Saul Centers White Flint Sketch Plan No. 320140010

Completed: 04/04/2014

RE: Sketch Plan No. 320140010
Saul Centers White Flint

Alternate Street B Layout

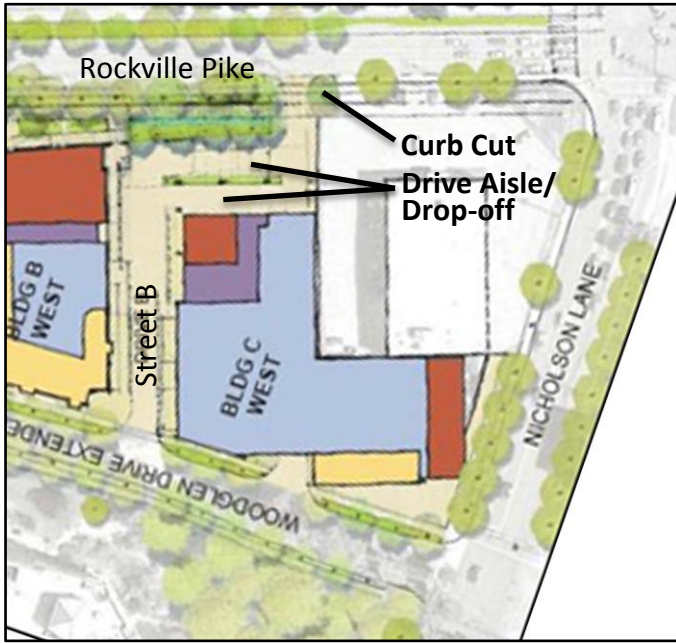
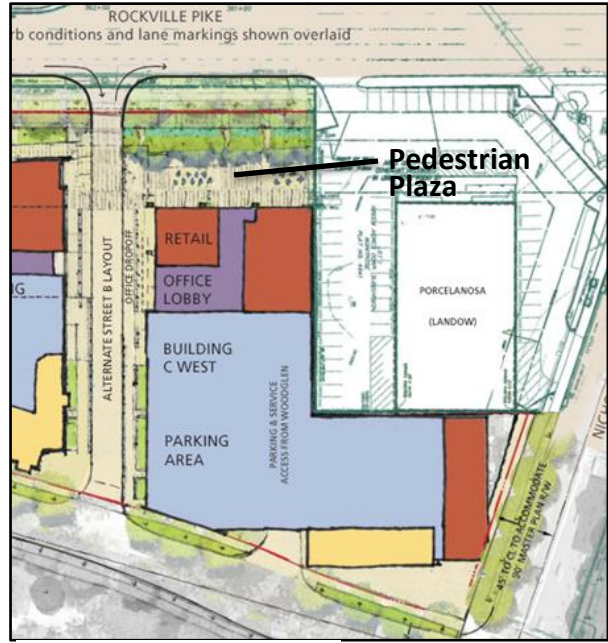
The revised layout will eliminate the curb cut nearest the Landow property and parking, loading, and service areas for Building C West will be accessed from the Woodglen Drive Extended only. The drive aisle and drop-off area in front of *Building C West* along Rockville Pike will be replaced with a plaza for pedestrians only. The Project described below and reviewed for analysis and findings in this report is based on the Alternative Street B Layout.
